UCLH Phase 4 & PBT
External Works Section JJ KK

UCLH Phase 4 & PBT
Roof Package Location Plan

UCLH Phase 4 & PBT
Roof Package Plans - First and Third Floor
Level Courtyard Building

UCLH Phase 4 & PBT
Roof Package Plan - Fifth Floor Level Atrium Roof

SEC-JJ External Works-Paramount Court Basement Junction
143707 1:10

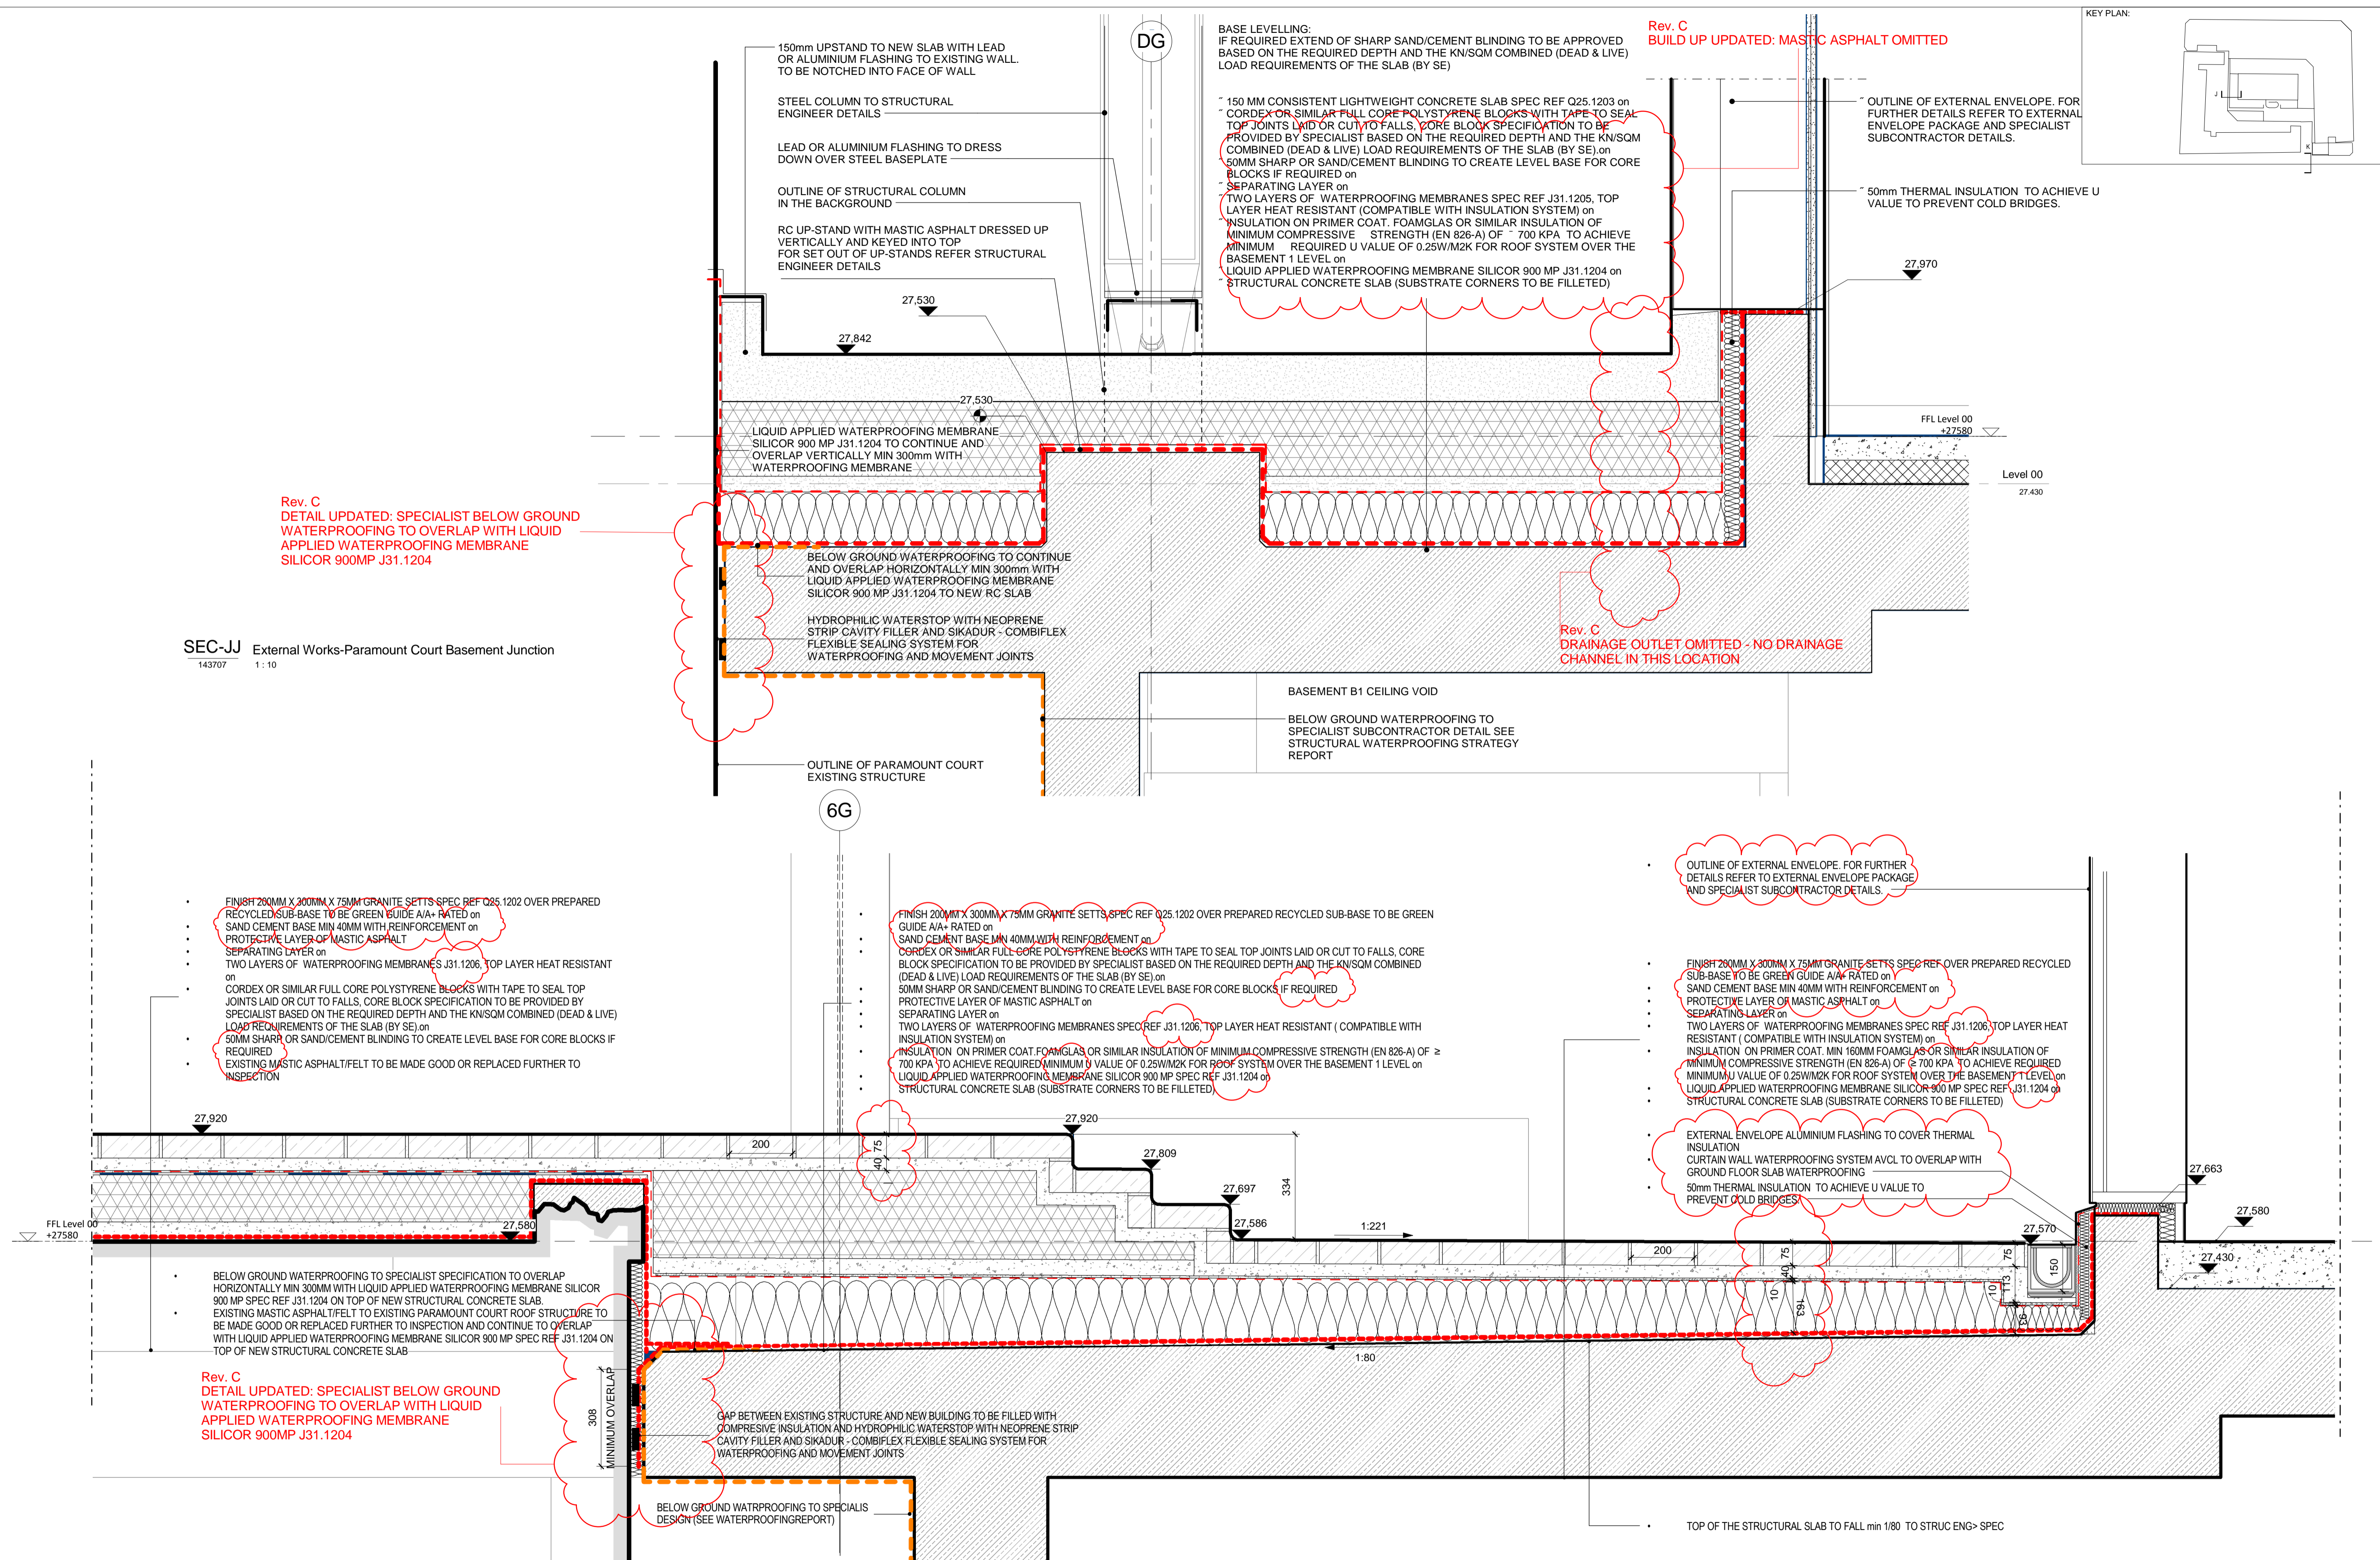
Rev. C
BUILD UP UPDATED: MASTIC ASPHALT OMITTED

Rev. C
DETAIL UPDATED: SPECIALIST BELOW GROUND
WATERPROOFING TO OVERLAP WITH LIQUID
APPLIED WATERPROOFING MEMBRANE
SILICOR 900MP J31.1204

Rev. C
DRAINAGE OUTLET OMITTED - NO DRAINAGE
CHANNEL IN THIS LOCATION

Rev. C
DETAIL UPDATED: SPECIALIST BELOW GROUND
WATERPROOFING TO OVERLAP WITH LIQUID
APPLIED WATERPROOFING MEMBRANE
SILICOR 900MP J31.1204

R/F-01 First Floor Plan
143141 1:100

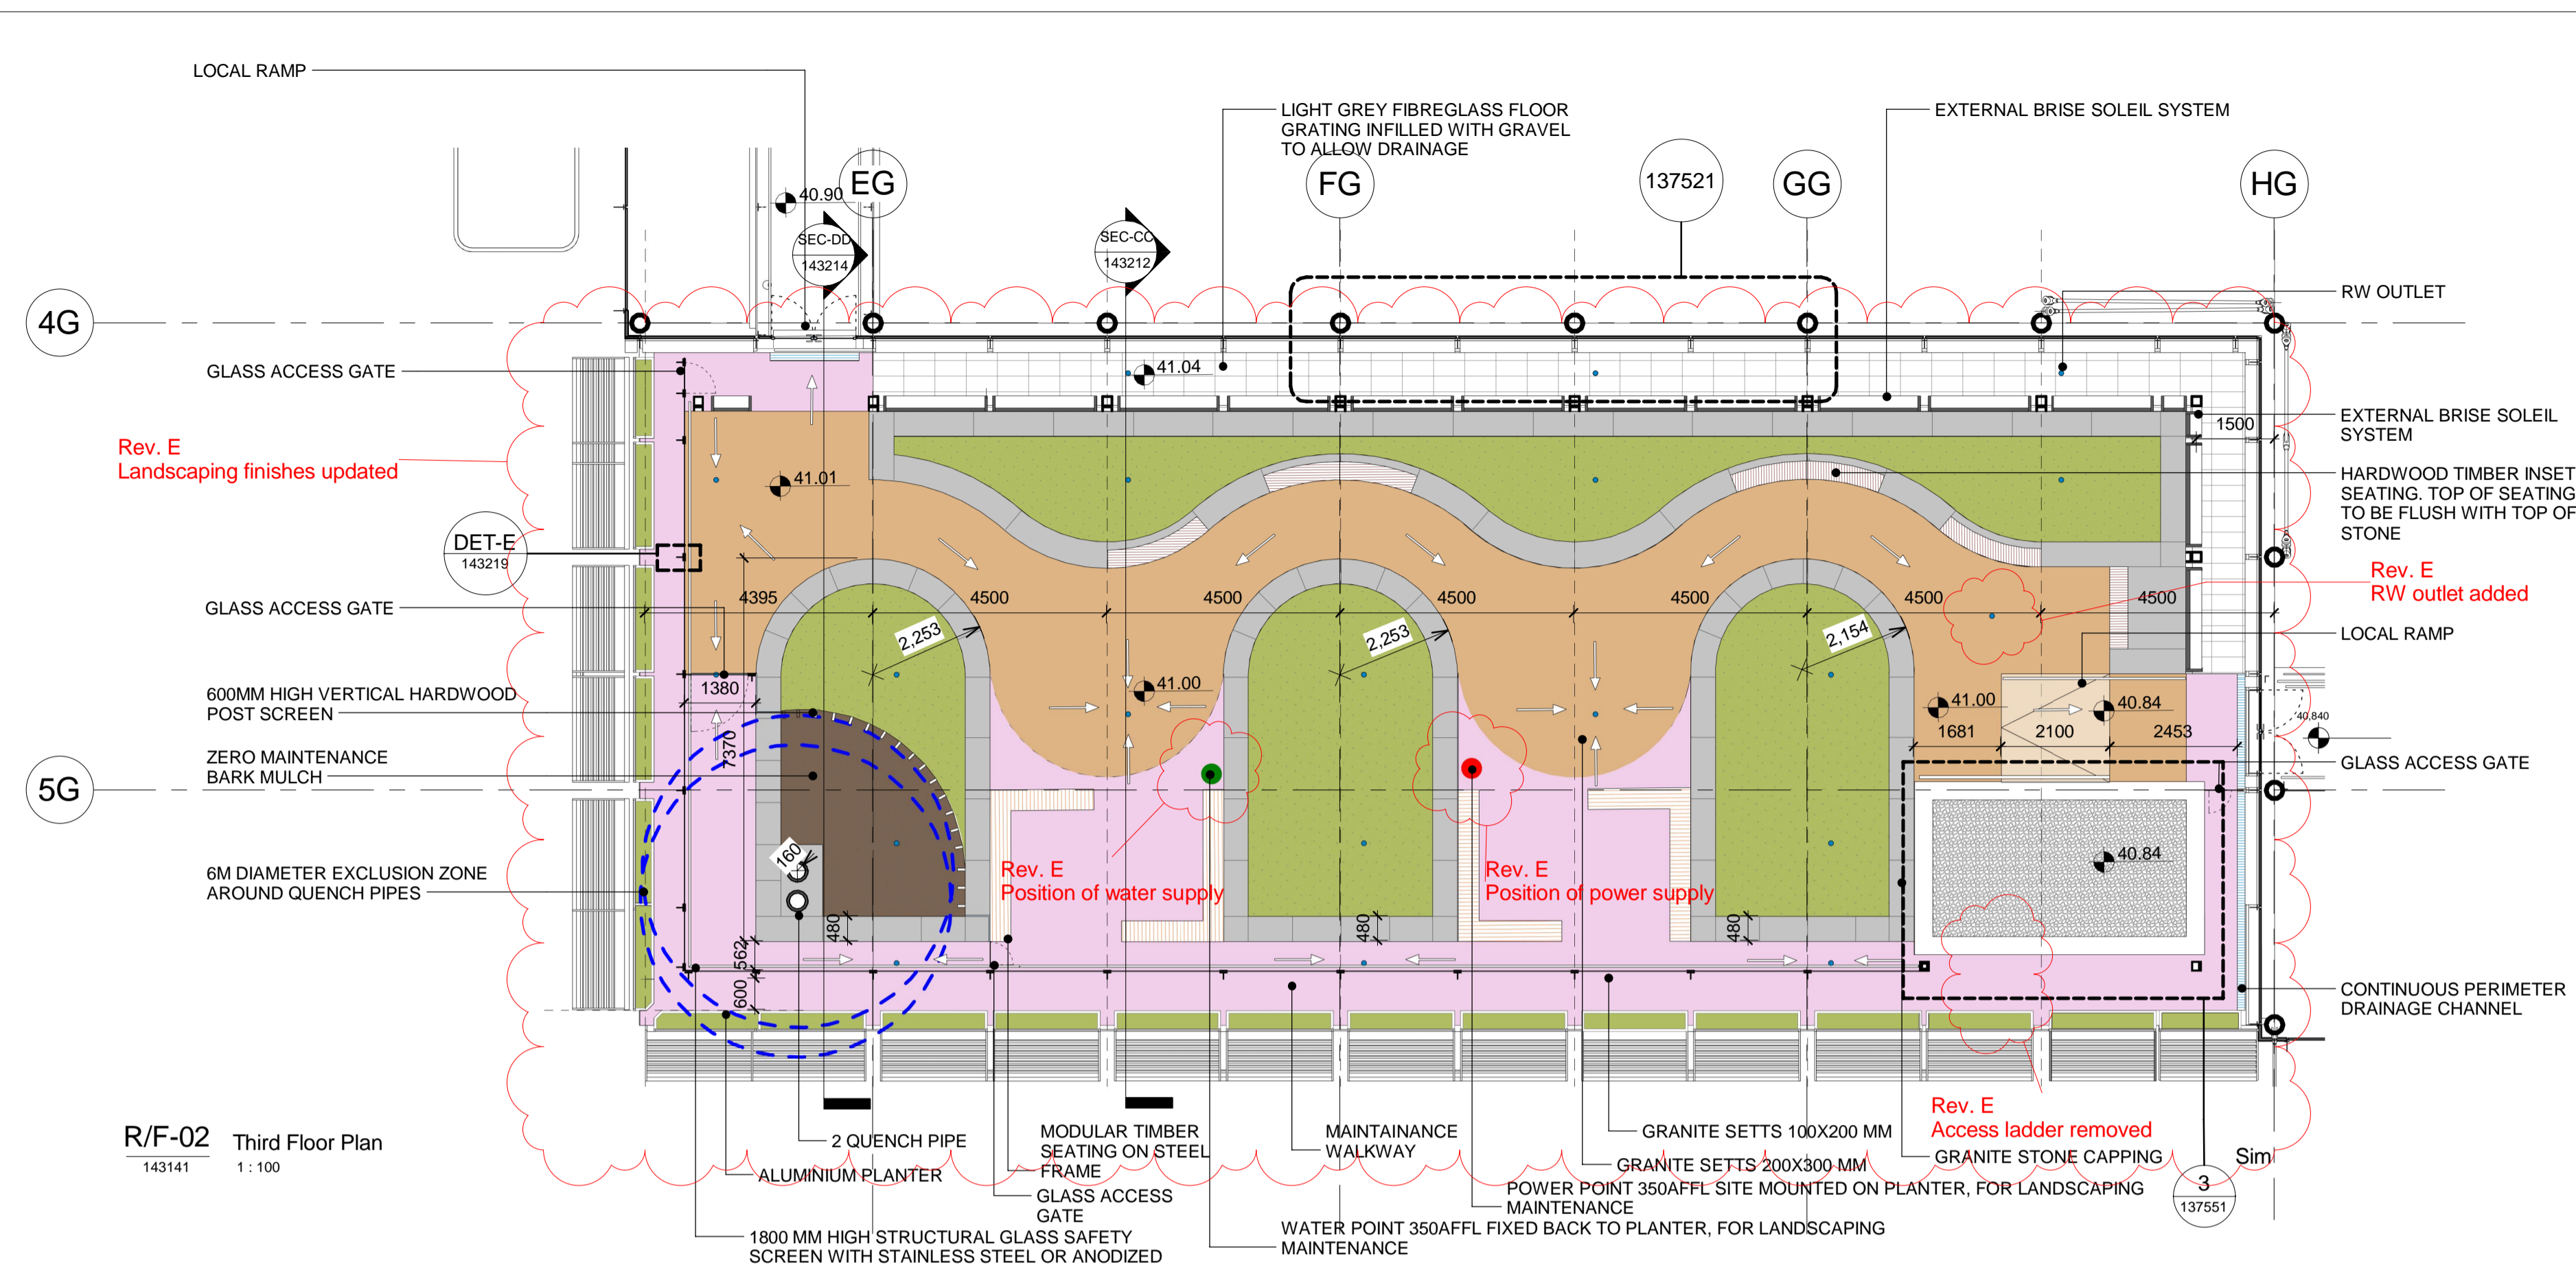
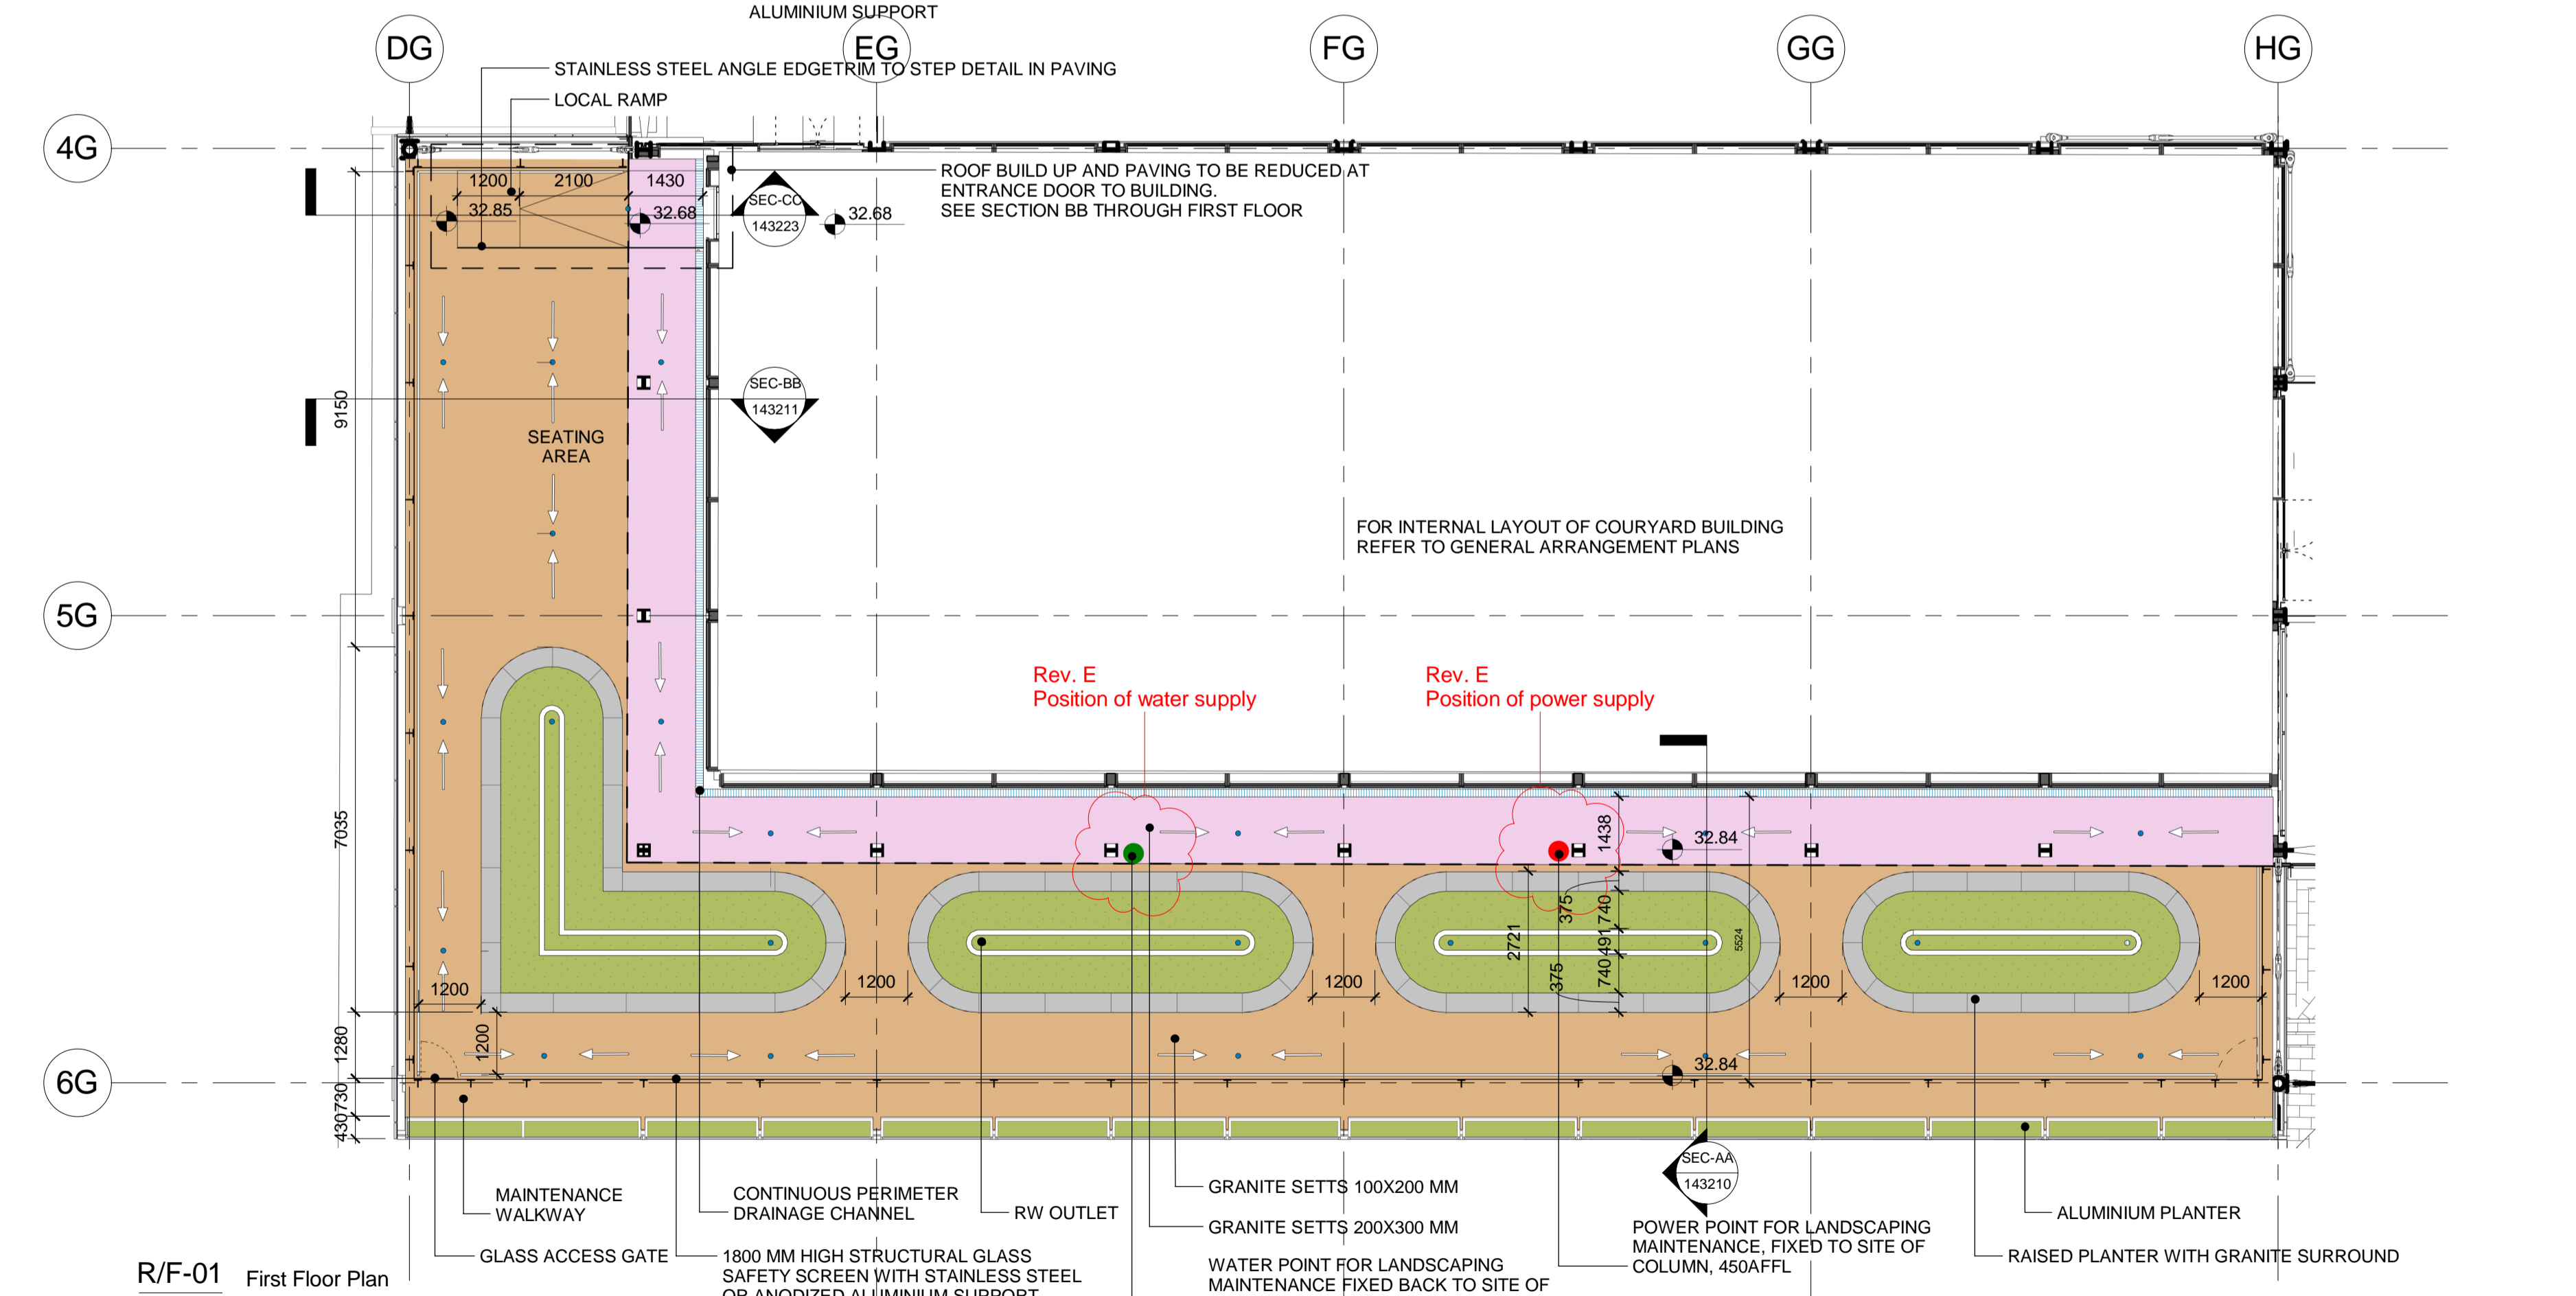
Rev. E Colour amended for clarity

Rev. E Finishes added to legend

Rev. E RW outlet added

Rev. E Note amended.

Rev. E Colour amended for clarity

Rev. E Colour amended for clarity

Rev. E Items added to legend

Rev. E Power and Water supplies added
